TABLE 1 – LFG GENERATION RATES (M³/HOUR) FOR A RANGE OF WASTE MOISTURE CONTENTS (MC%)

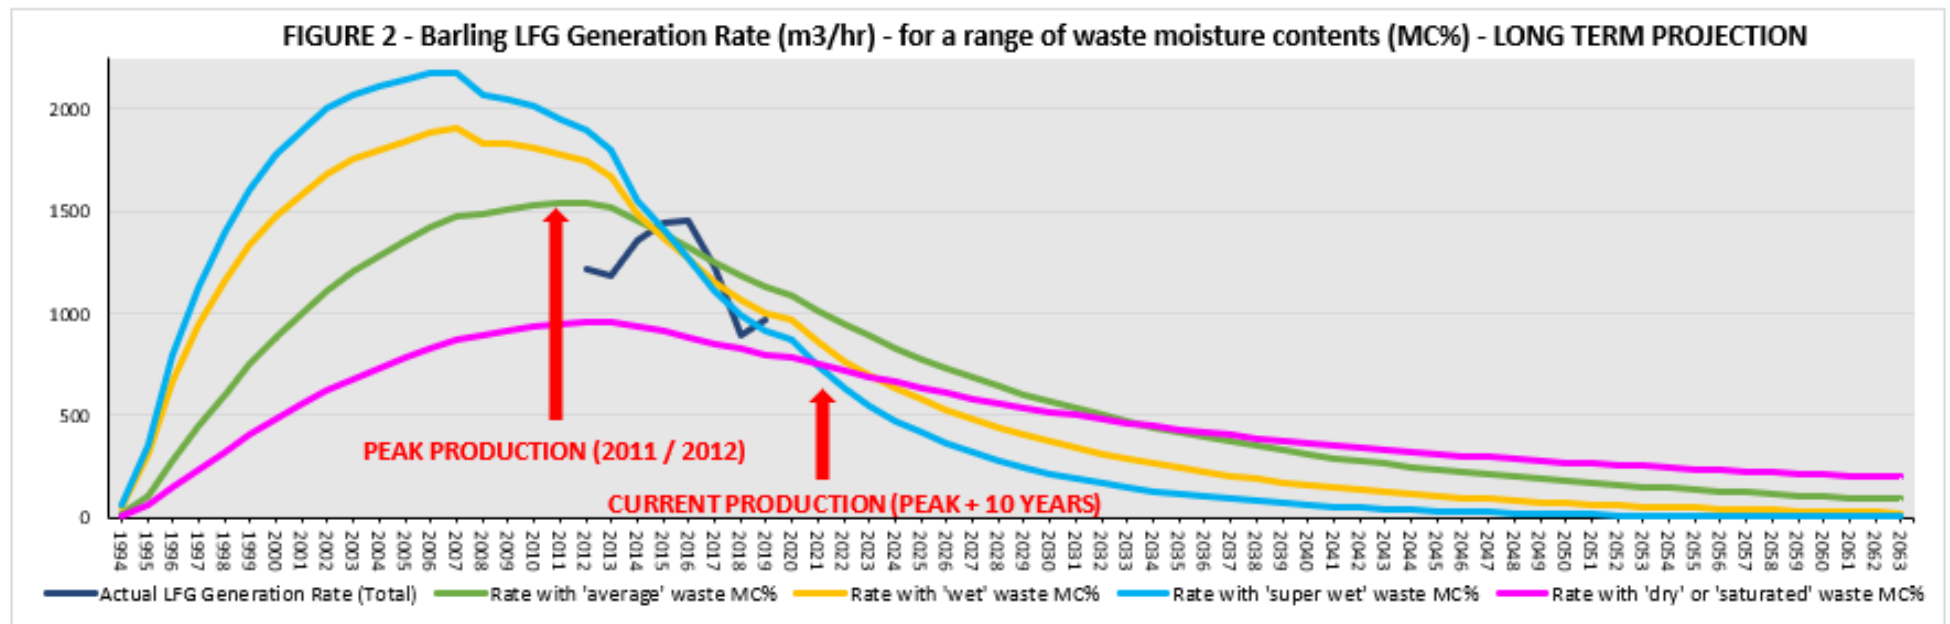
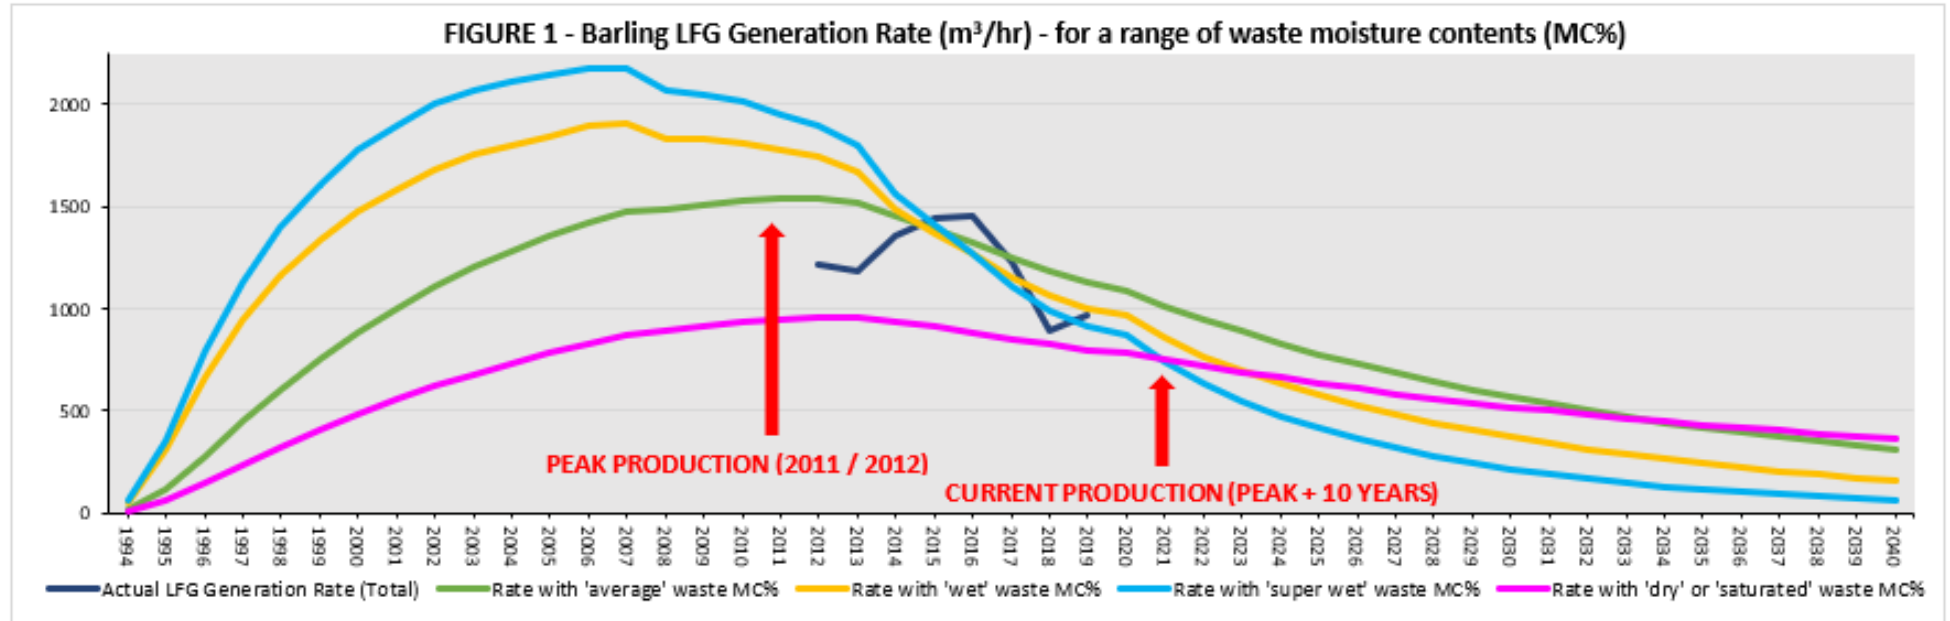
In view of the proposed changes you need to provide updated expenditure plan for Financial Provisions to take account of the proposed changes. No assessment has been undertaken to determine whether proposals will result in increasing the length of the aftercare period. It is possible higher leachate head will saturate the waste which could slow the rate of biodegradation of waste.

Figure 1 (below) shows the LFG generation rates when modelled using a range of waste moisture contents including 'dry', 'wet', 'saturated', 'super wet' and 'average'. In addition, as a check on the accuracy of the model, the actual rate of LFG extraction is plotted as well. It is clear from the graph that whilst there are differences both in the timing and peak of LFG generation rates, the curves are broadly consistent, with little overall difference. What is evident is that a wetter waste mass means the peak LFG production rate is earlier and greater, but subsequent residual LFG generation rates are lower. The drier the waste, the lower and later the peak LFG production rate is, but the subsequent residual rate of production remains higher for longer. What is important is the total LFG volume generated (which can be represented by the area below the plotted curve) remains the same. The waste retains the same biodegradable component, and can only generate a set volume of LFG, but the rate at which it does so can change.

Figure 2 (below) shows the same curves, generated from the same modelling, but extended forward (until 2063) to show a fuller picture of long-term residual LFG production. The data used to generate the curves in Figures 1 and 2 is presented in Table 1.

- The actual rates of LFG extraction measured at the site compare favourably with the modelling, especially when an 'average', 'wet' or 'super wet' waste moisture content is used.
- Wetter waste returns a greater and earlier peak of LFG production, **but a lower residual production rate**.
- The modelled peak of LFG production at Barling occurred almost 10 years ago (2012) and LFG generation rates at Barling are reducing.
- Similarly, the rate of LFG extraction peaked around 5 years ago (2015) and is reducing.
- In terms of long-term aftercare (and therefore financial provision), a wetter waste mass results in a lower long-term LFG generation rate, requiring less infrastructure and less LFG management costs. The existing agreed level of financial provision currently in place is therefore considered adequate.

Figure 3 – Site Cross Sections Comparing Existing Permitted Leachate Level, Proposed Leachate Level, and Actual Leachate Levels

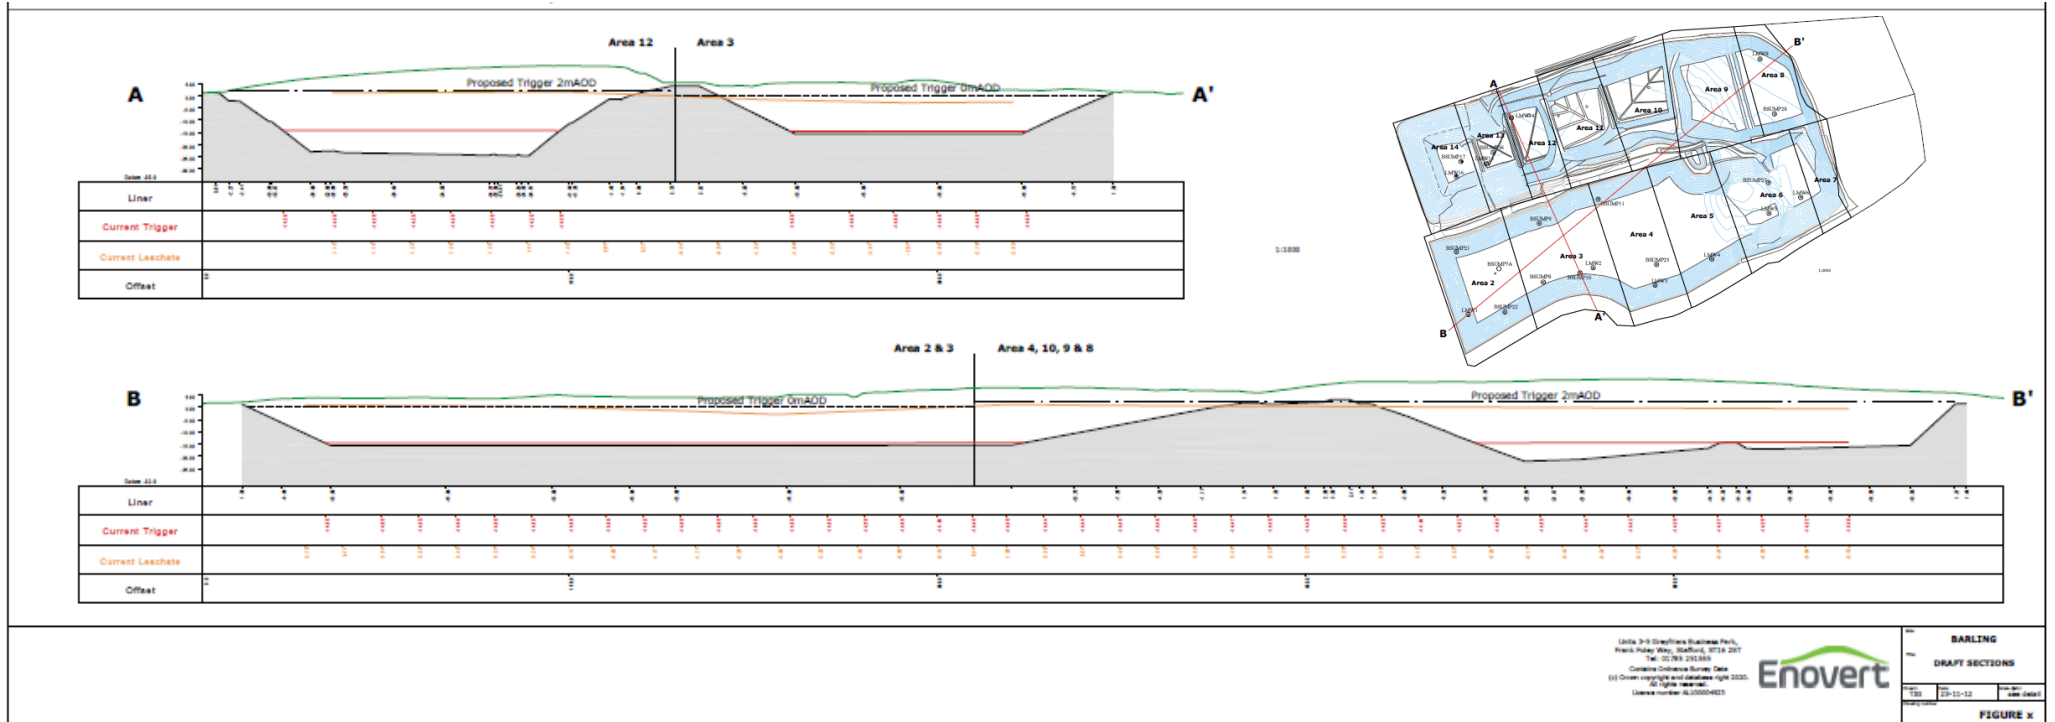
An assessment of the depth of unsaturated waste from which landfill gas may be abstracted by the existing landfill gas system must be submitted.

The relationship between the current permitted leachate control levels, the proposed leachate control levels and the actual leachate levels within the site is shown in Figure 3 below. This shows two cross sections taken lengthways and crossways across the site, and clearly shows that the leachate control levels being proposed will not result in any significant changes to the extent of the leachate body.

Given the actual leachate levels present at the site over recent years, this comparison (current permitted leachate levels to proposed leachate levels) will not accurately predict the potential effects of the permit variation. Leachate levels at Barling are already broadly consistent with the levels being proposed in the variation, so the proposed changes will have little net change in the leachate levels. A more accurate assessment of the potential effect that the proposed variation will have on the current ability to extract LFG would be to compare the **current actual leachate levels** with the **proposed leachate levels**.

Figure 4 – Perimeter Landform Cross Sections

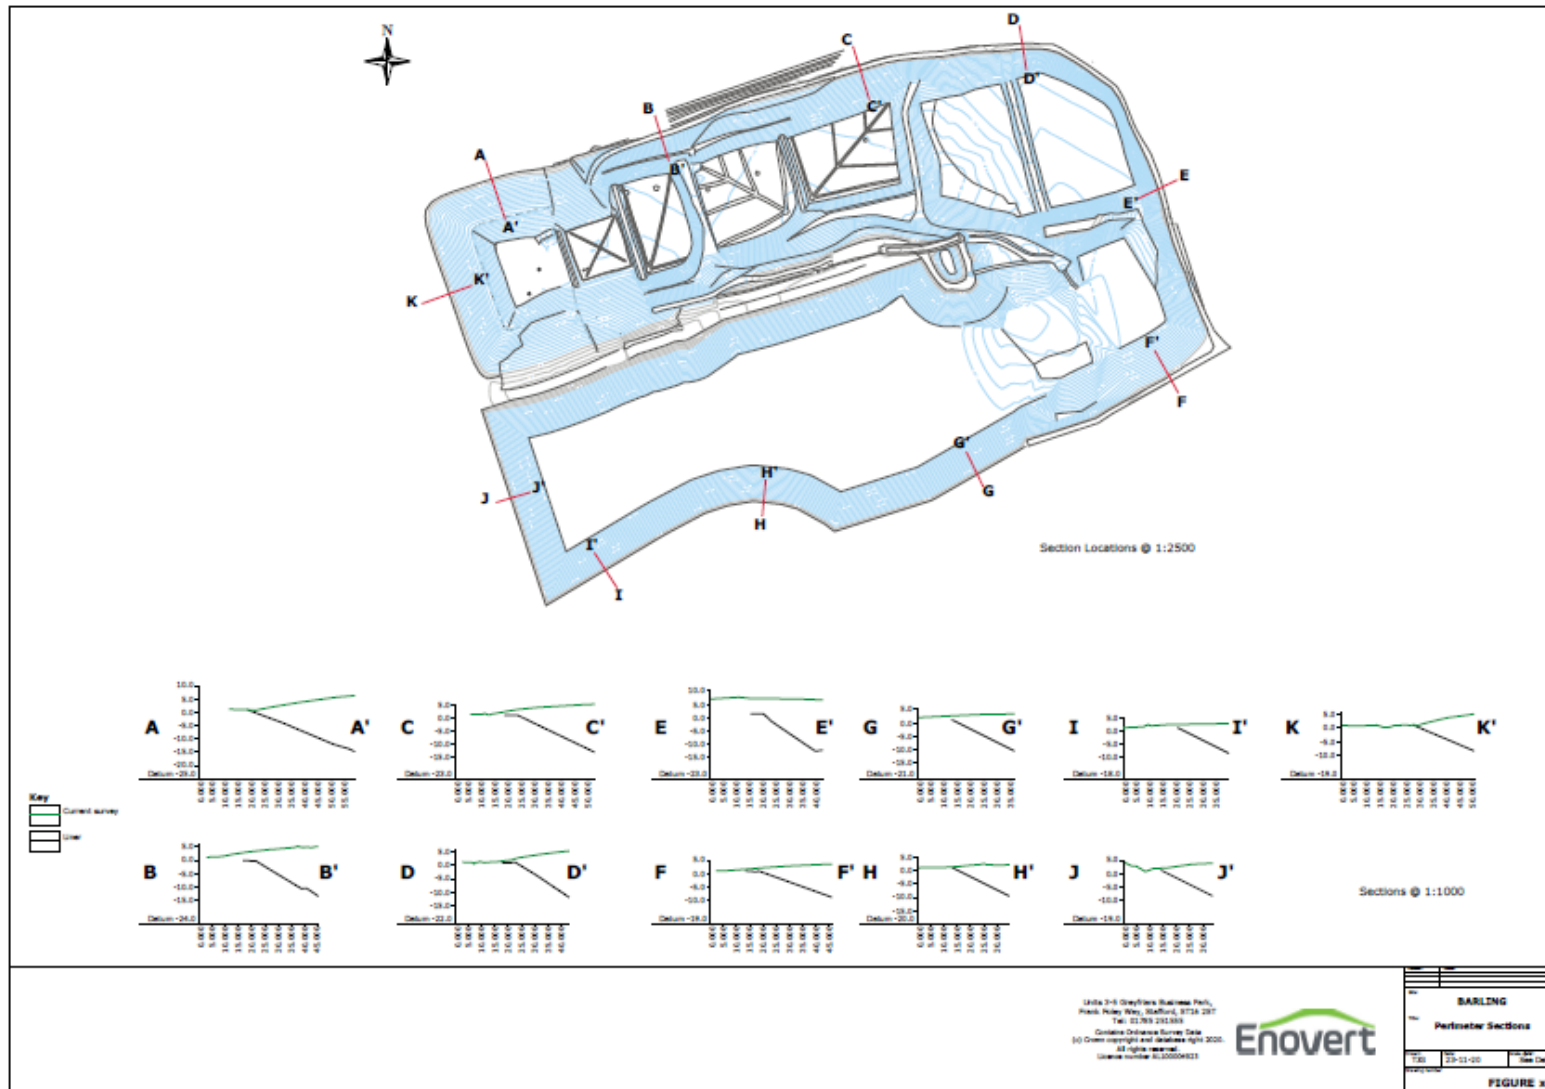
Please provide a revised Stability Risk Assessment which considers the impact of the proposed changes to the leachate level on the landfill infrastructure.

The site is effectively completed; waste infilling has finished, and the site is capped and restored apart from the area around the most recent phases. As such there are no sections of the site with unsupported waste slope, internal waste flanks, exposed basal or sidewall liners etc. There are no sections of the site where the waste mass can become unstable, and the majority of waste settlement is nearly completed across much of the site. As such it is difficult to envisage a scenario whereby the leachate trigger levels proposed can affect the structural integrity of the site in its current form and stage of development.

The exact nature of the waste slopes and profiles is shown in the perimeter landform cross sections set out in Figure 4 (above).
